PROPOSED S4.55 CHANGE LIST

Client
Project Name
Castlecrag Quadrangle

Drawing Title
BASEMENT 01 PLAN

Drawing No
A10-0900

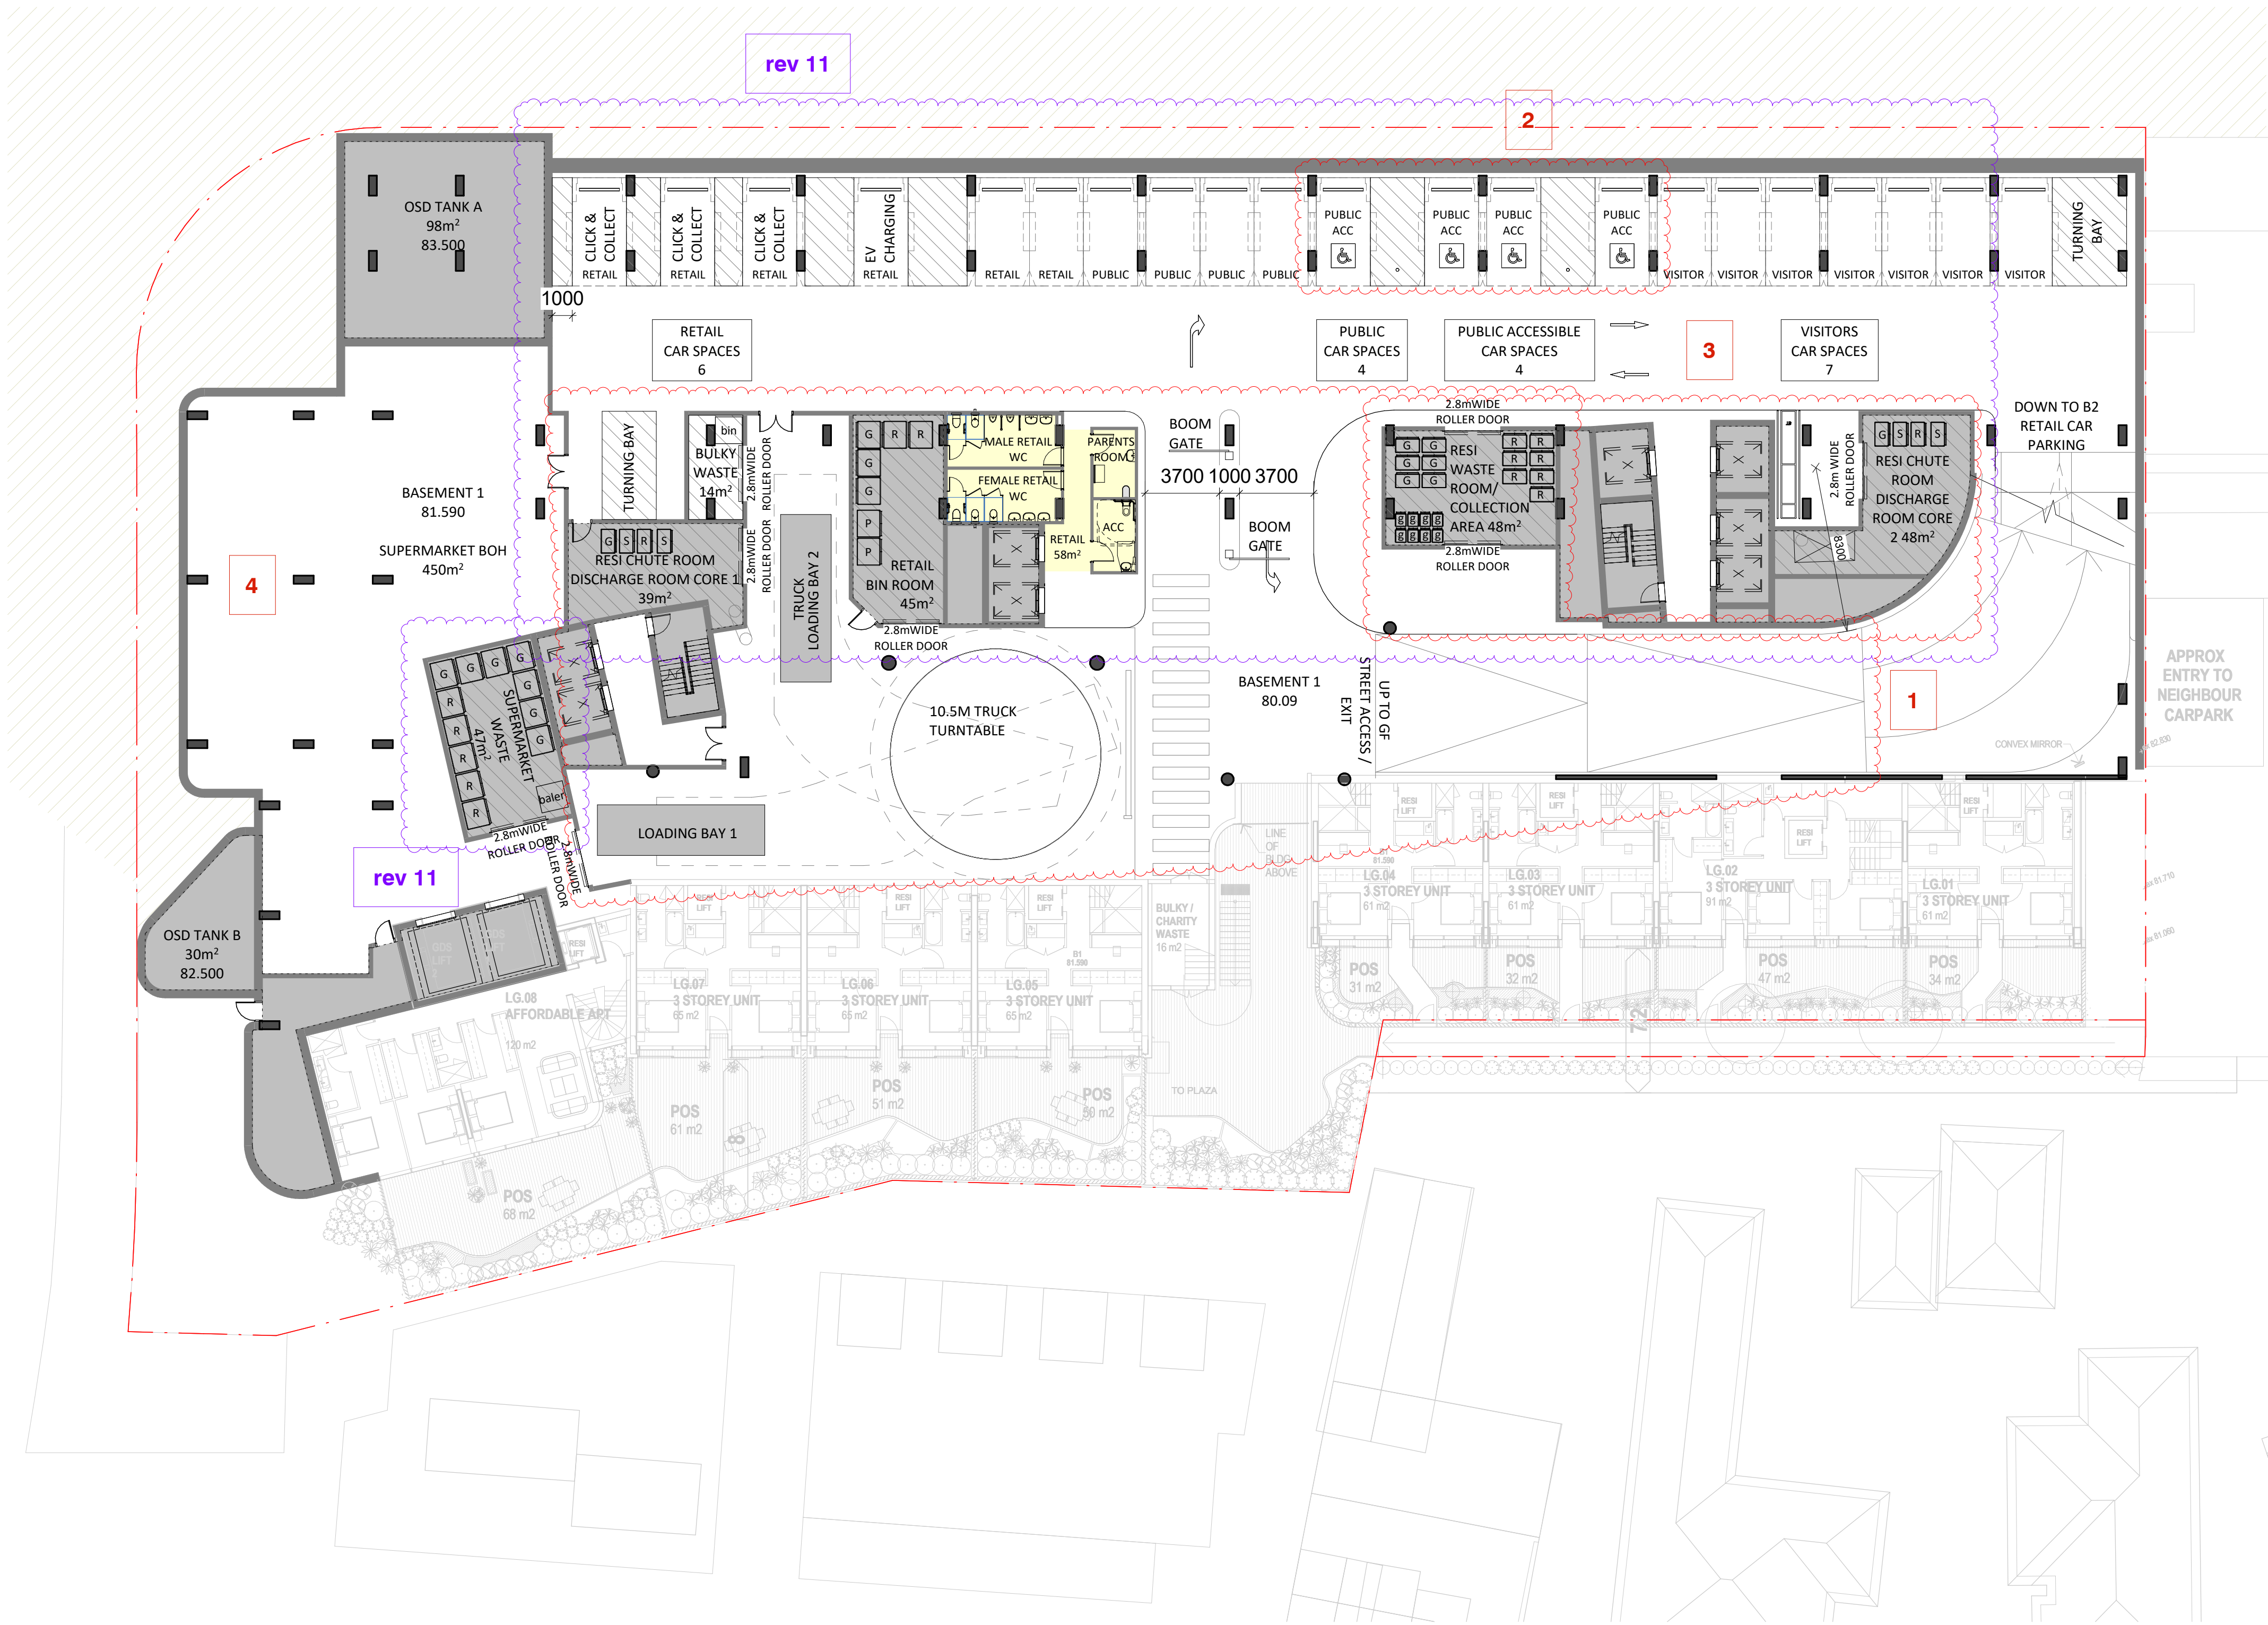
1. LOWERING THE SLAB LEVEL OF THE DA APPROVED B1 TO IMPROVE OPERATIONAL EFFICIENCY, FUNCTIONALITY AND DURABILITY FOR USERS. TRUCK OVERHEAD CLEARANCE LEVELS UNDERSLAB INCREASED TO ENSURE COMPLIANCE. RAMP DOWN TO B1 INCREASED, LOADING DOCK PUSHED TO THE LEFT AND BOOM GATES RELOCATED TO ALLOW SPACE FOR RAMP.
2. PUBLIC ACCESSIBLE PARKING PROVIDED INCLUDED IN THE 8 PUBLIC PARKING SPACES PROVIDED
3. RESI WASTE AREAS PROVIDED
4. COLUMNS INCLUDED AFTER INITIAL CO-ORDINATION WITH THE STRUCTURAL ENGINEER. BASEMENT PERIMETER COLUMNS NEEDED.
